ATA Security feature Set Clarifications

To: T13 Technical Committee
From: Jim Hatfield
Seagate Technology
(with Jeff Wolford: Hewlett-Packard)
389 Disc Drive
Longmont, CO 80503
Phone: 720-684-2120
Fax: 720-684-2722
Email: James.C.Hatfield@seagate.com
Date: May 24, 2006

I propose that the following be incorporated into ATA/ATAPI-8 ACS as a full replacement for the referenced sections.

Figure 1 - Security State Diagram

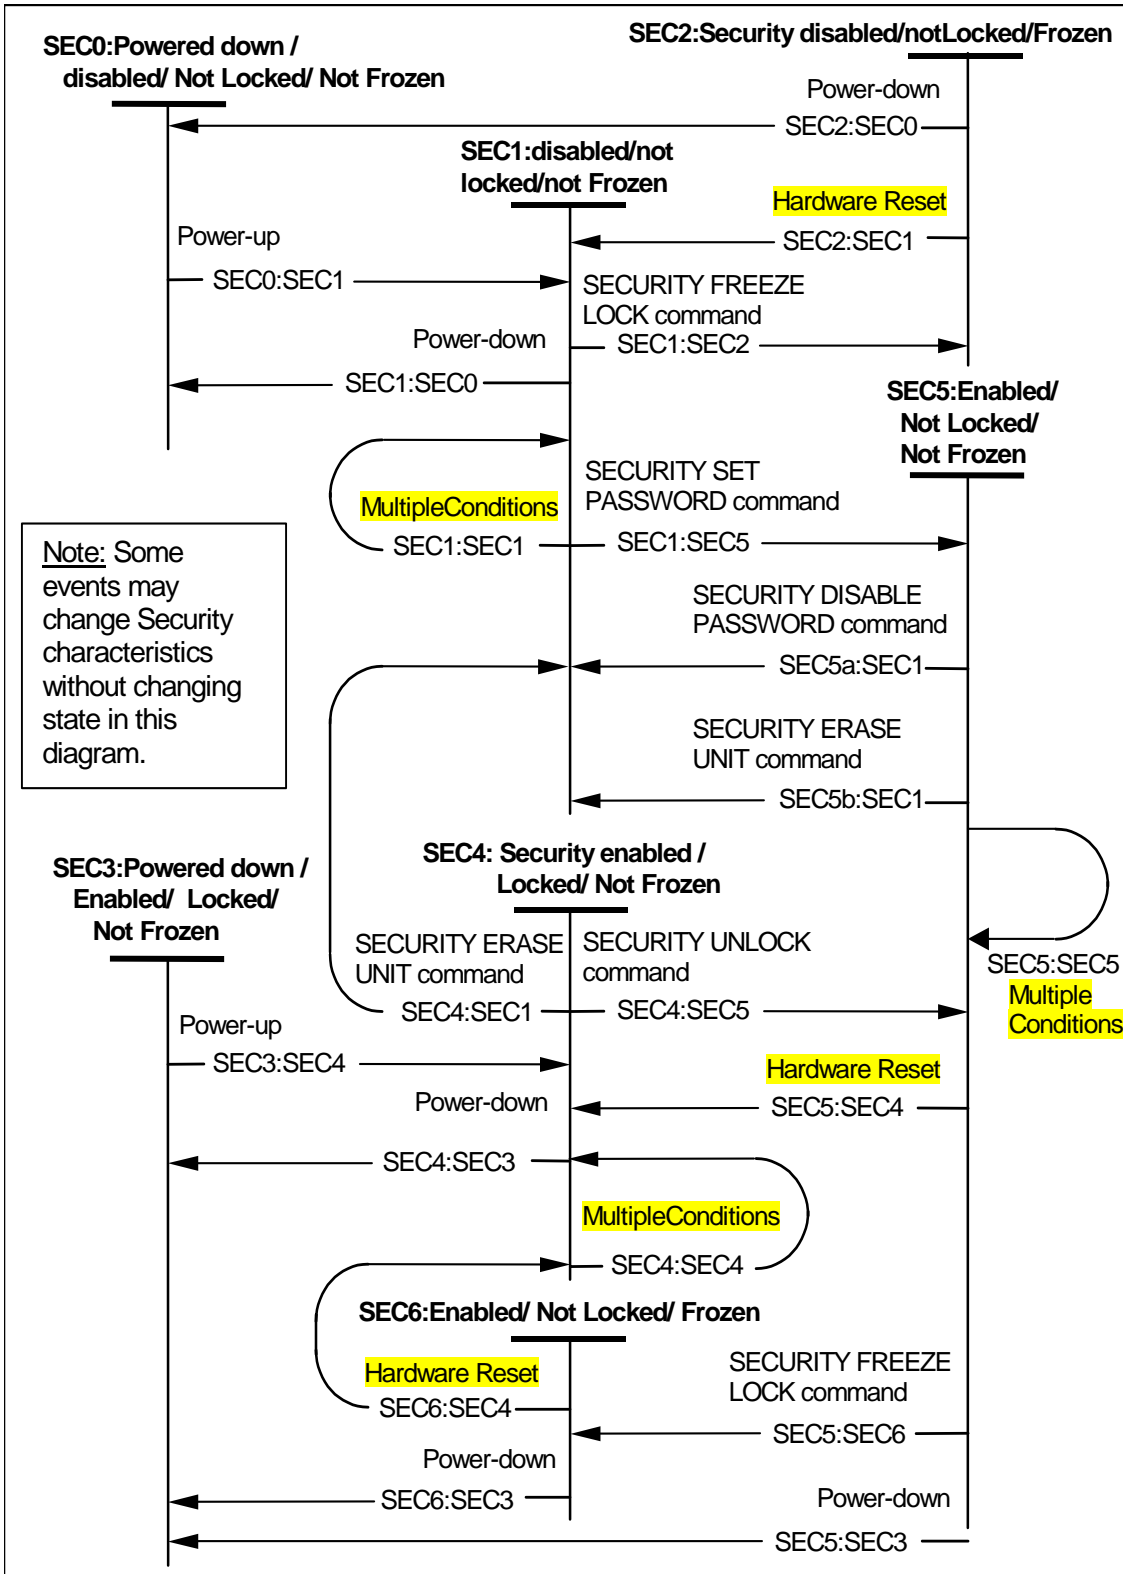
The SECURITY FREEZE LOCK command prevents changes to all Security states until a following power-on reset or hardware reset. The purpose of the SECURITY FREEZE LOCK command is to prevent password setting attacks on the security system. [Editors note: fix the figure or fix this text]

[Editors note: do we need this loopback ? what about non-security commands ? is this list of events inclusive or exclusive ?] [only needed if something special is done in the state – so not needed]

[Editors note: if the loopback is kept, should it be labeled ?]
